Reindeer Project Construction Services, Savoonga **EDA Project Number 07 79 07873**

Addendum #4 **7/17/2024**

Summary of items included in this addendum:

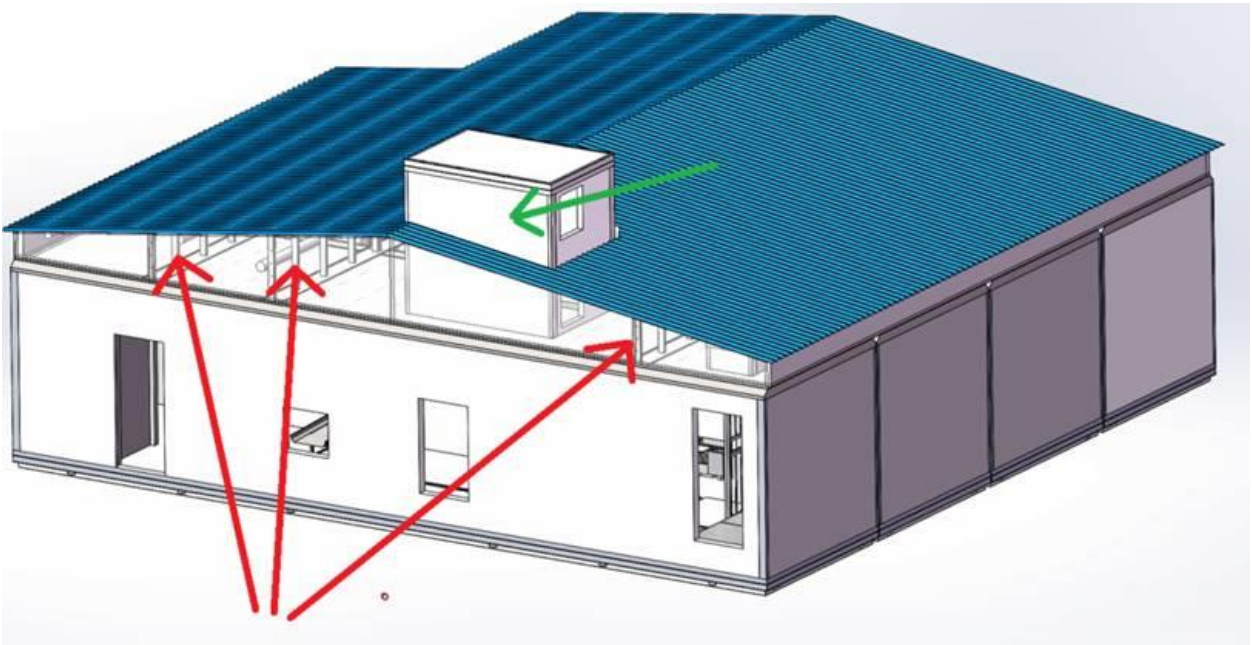
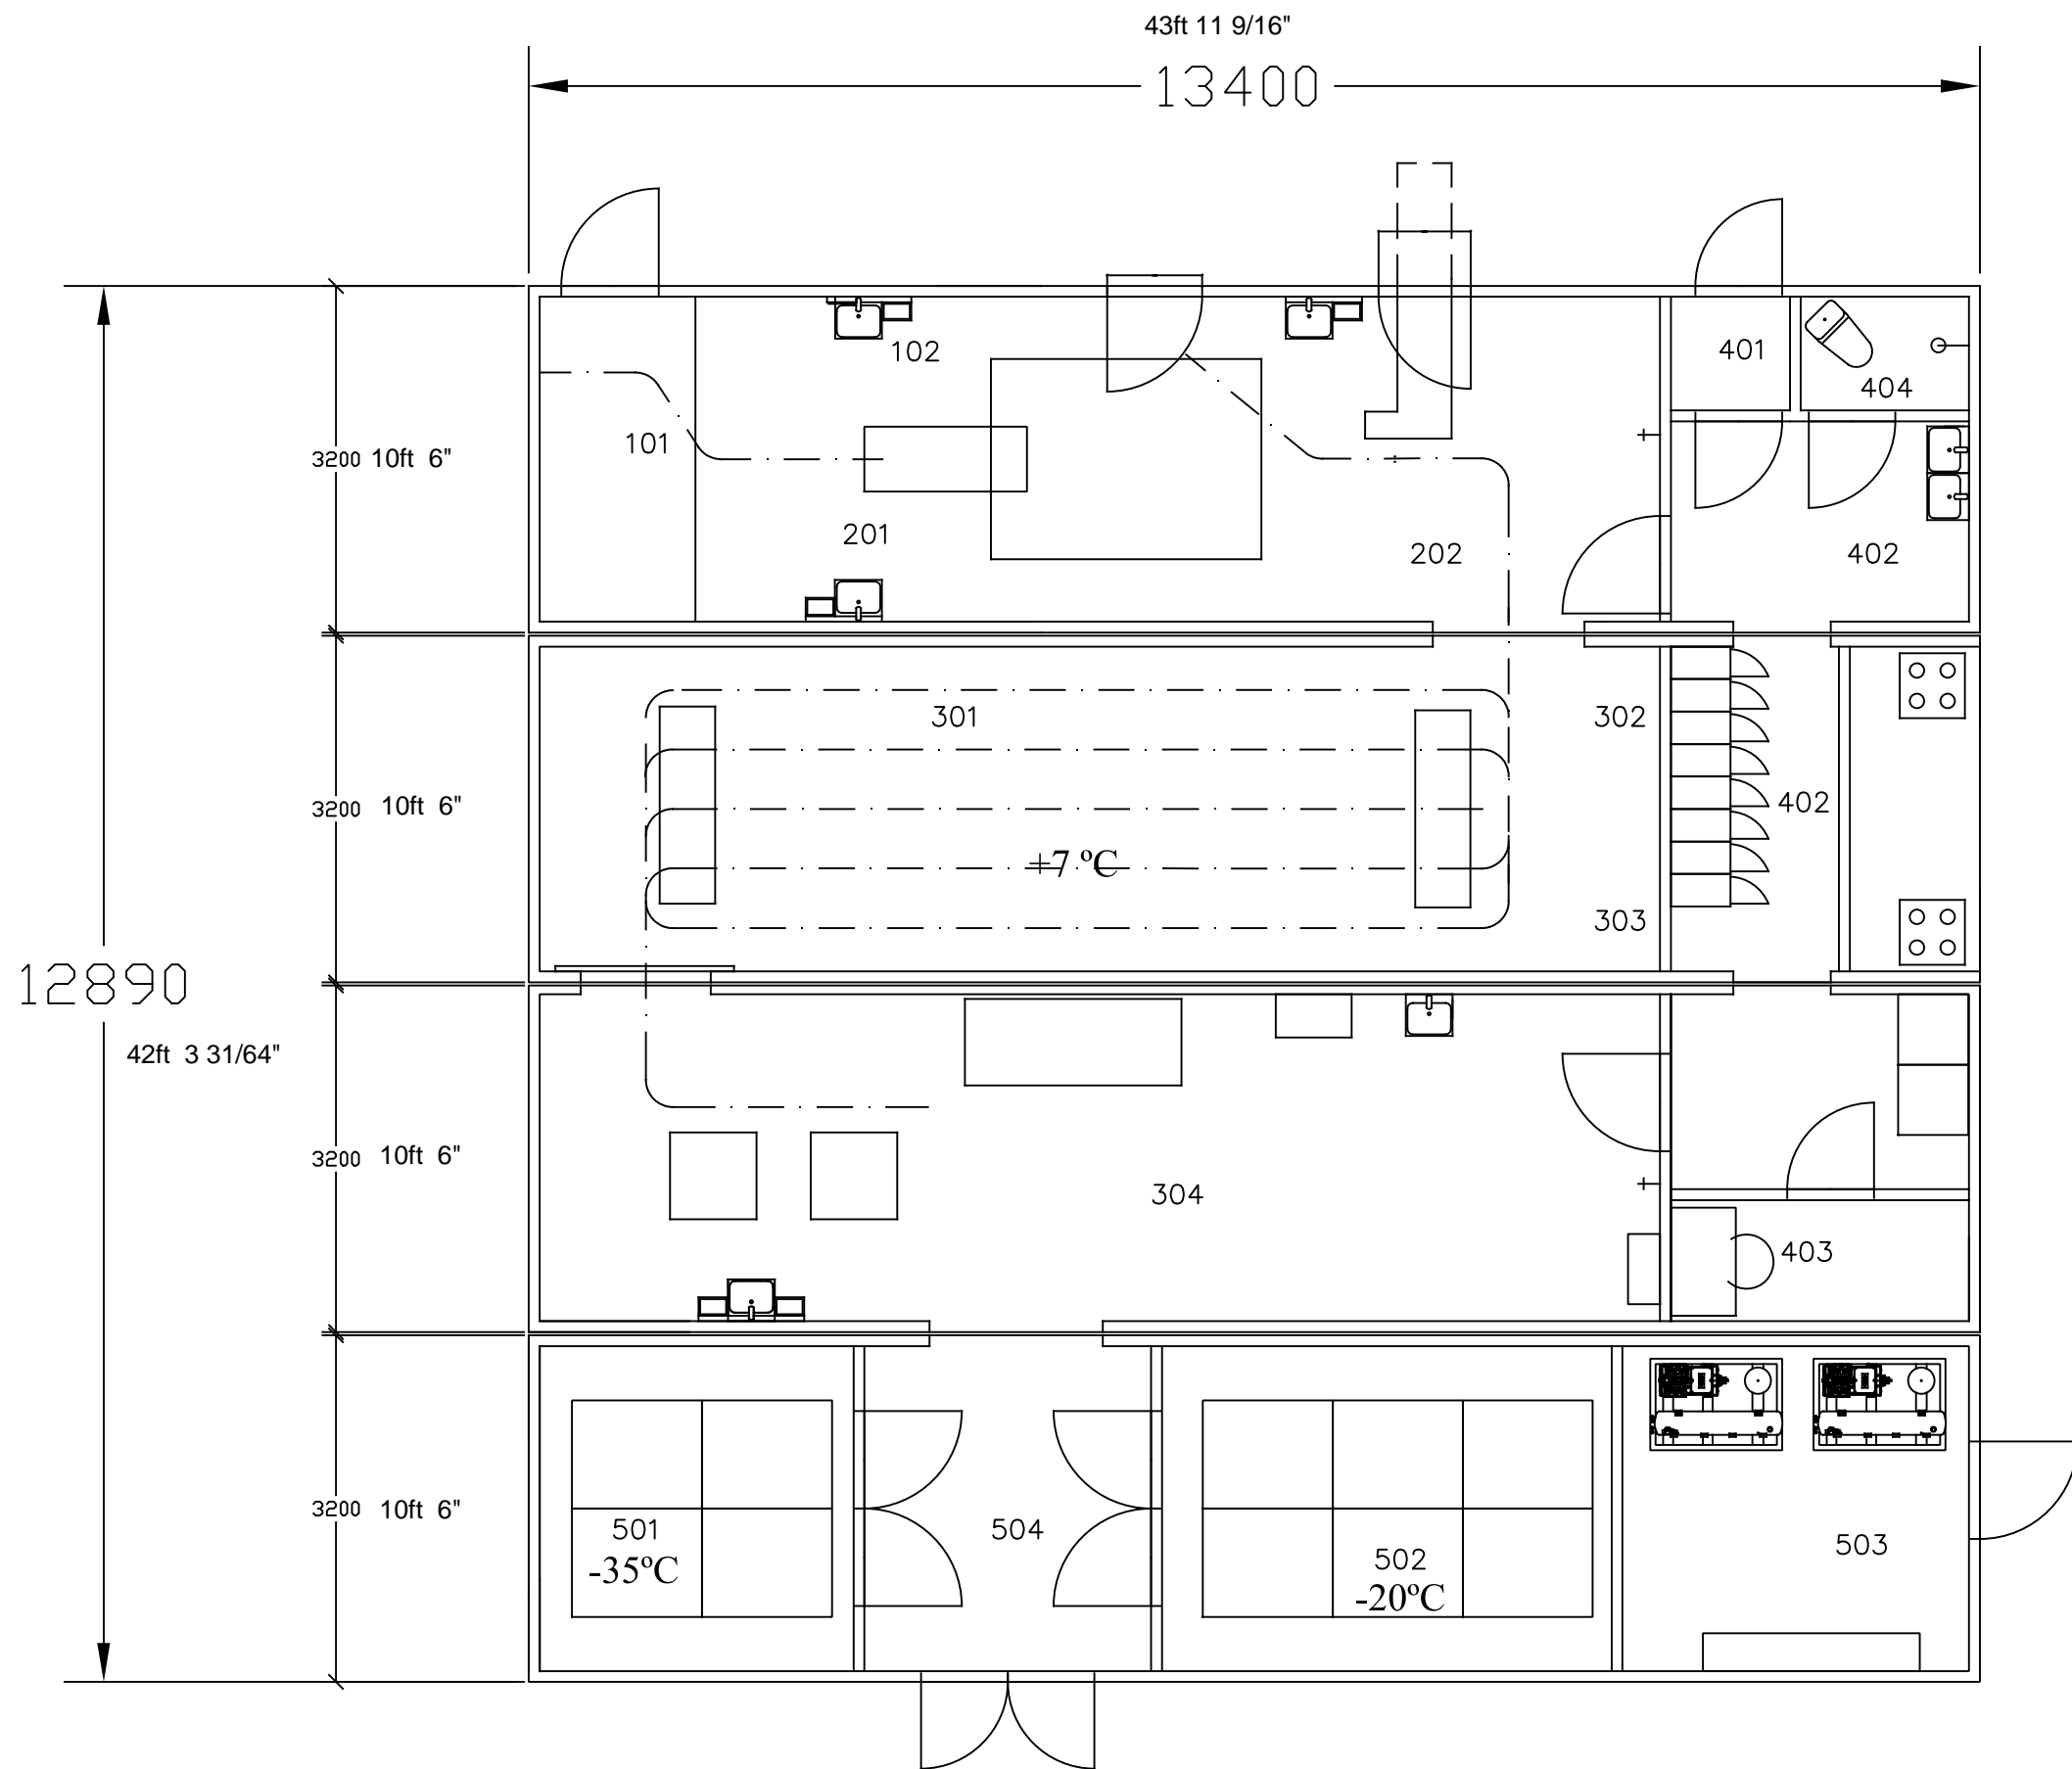
As per the structural details, the modules are connected to the foundation (by the GC) via welding the steel frame to foundation (pile) plates. The modules are not connected to each other structurally but doorways etc are connected and sealed using stainless steel sheet metal profiles and sealants. The roof structures will be connected to each module and the roofing basically binds everything together. The connection between modules and the roofing installation described above is completed by Kometos personnel.

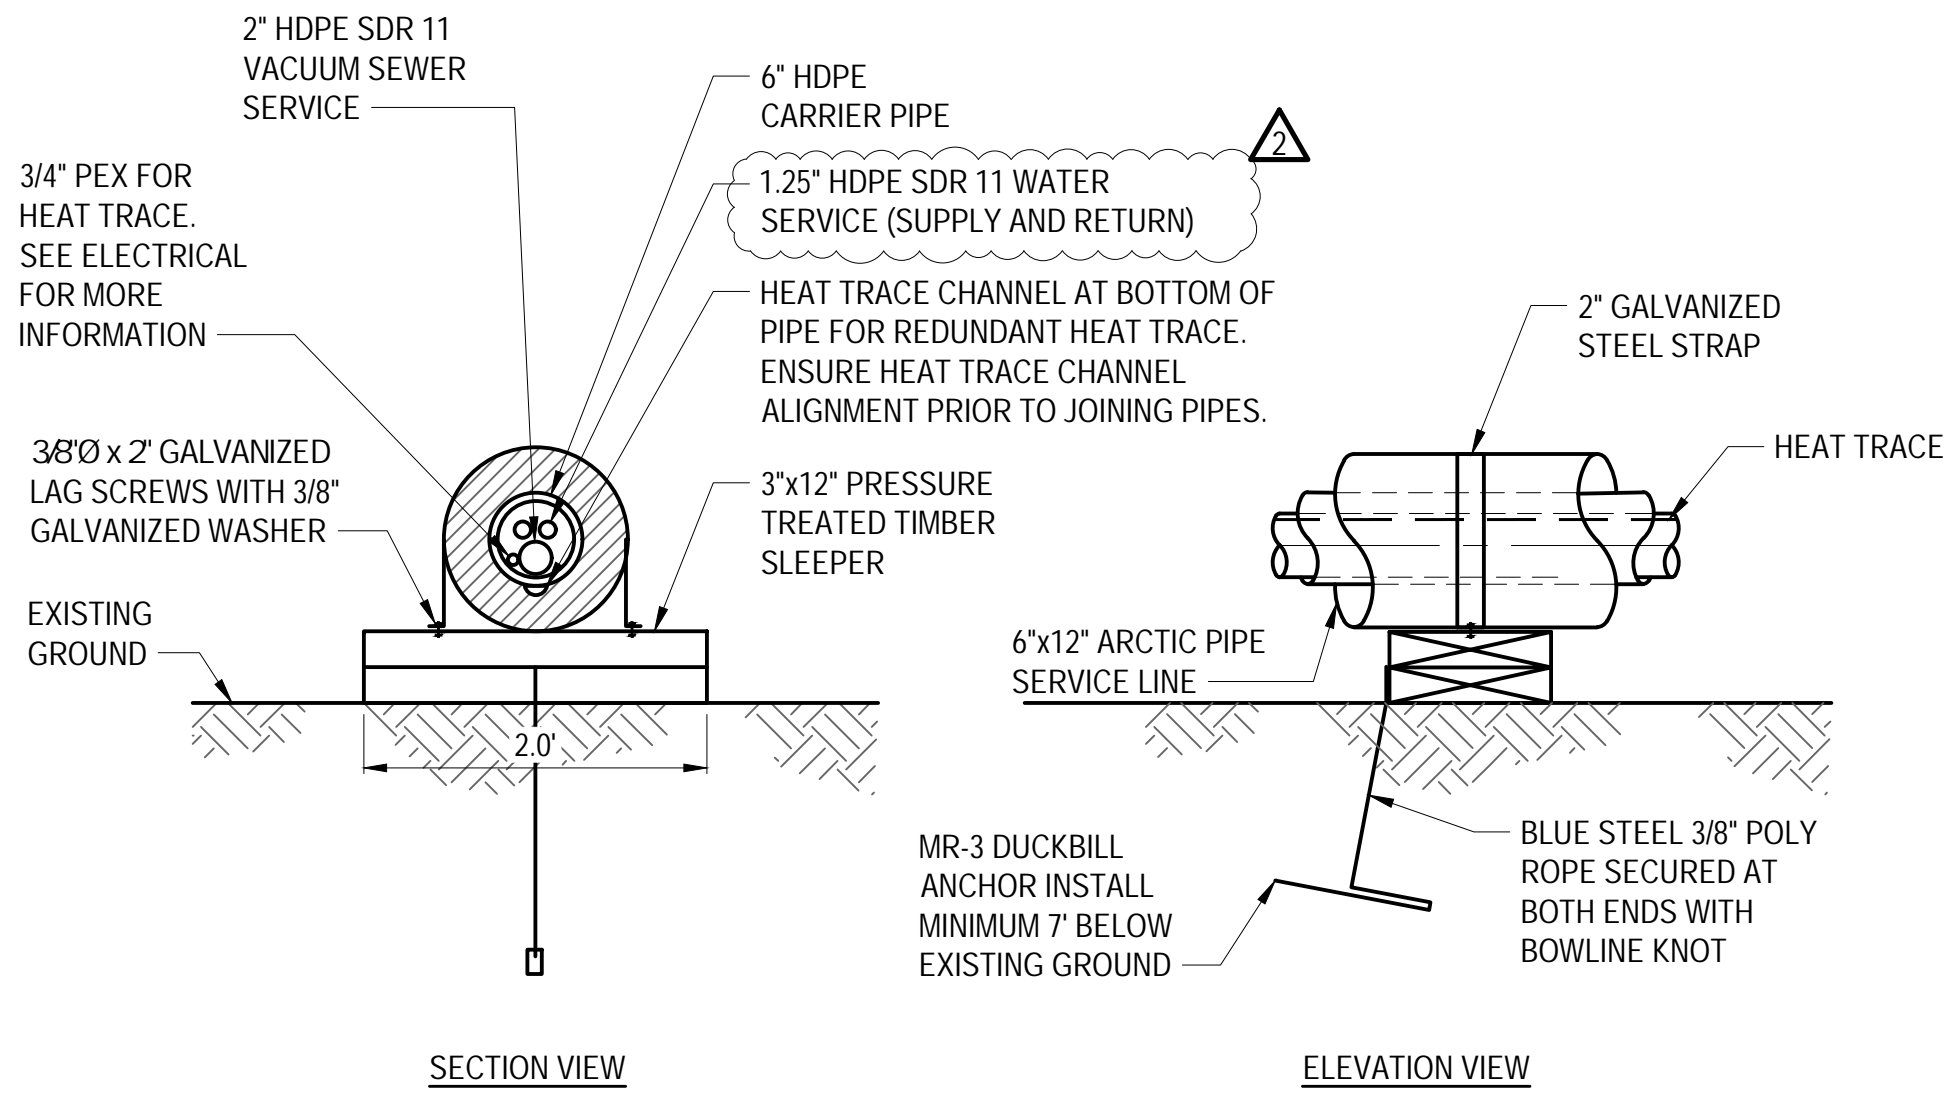
B	1	17.7.2024	TP	Moduuliv?it muutettu 30 mm
Muutos	Uusi	Päiväys	Piiri	Muutostoimenpide
				Technical room moved to other end

ARCTIC PIPE
DETAILS

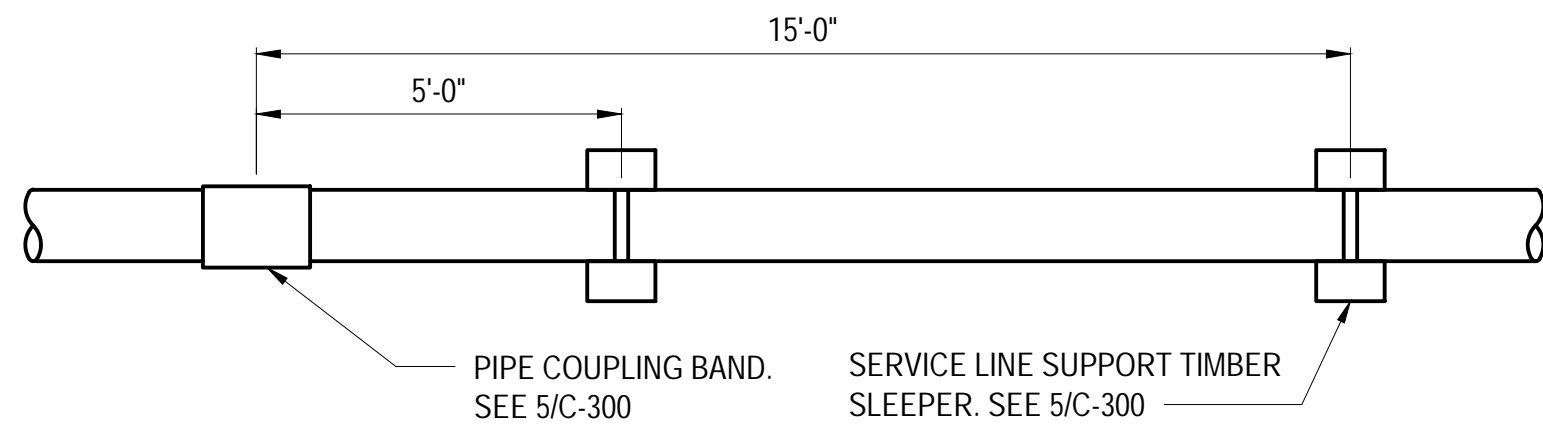
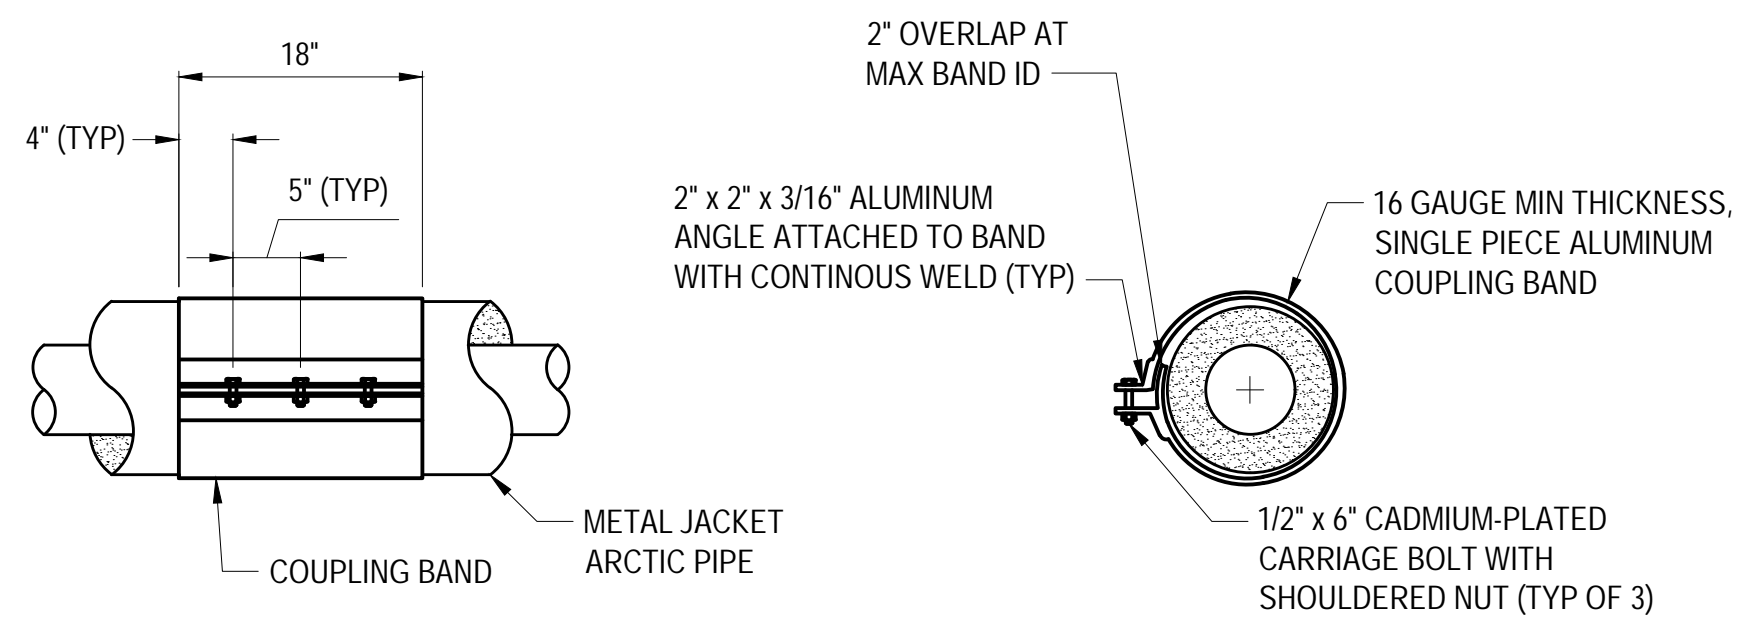
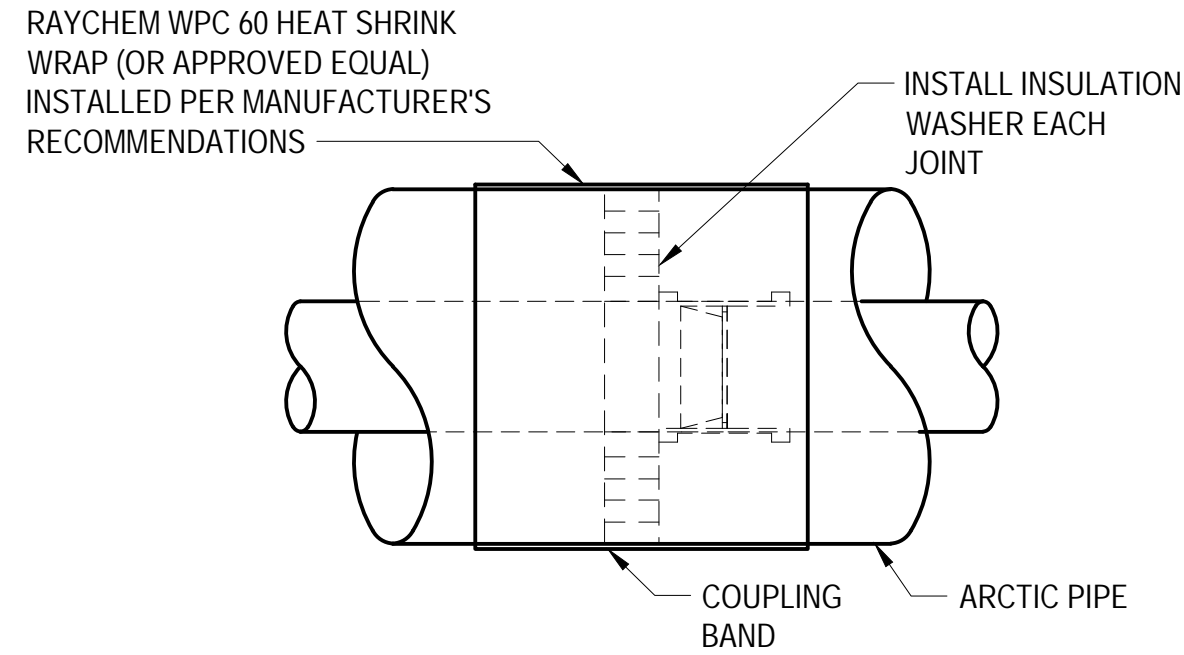
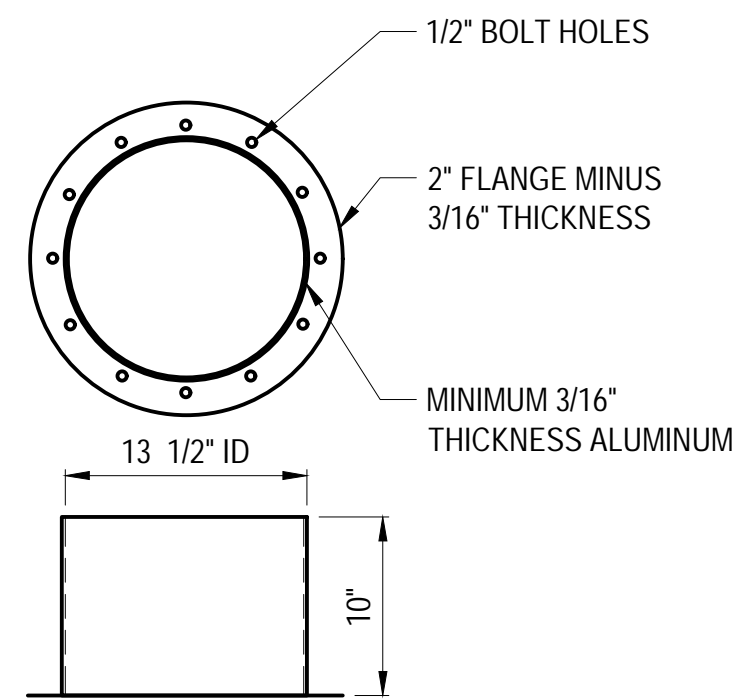
REV	DATE	DESCRIPTION
2	07/16/2024	ADDENDUM 4
1	03/18/2024	EDA COMMENTS
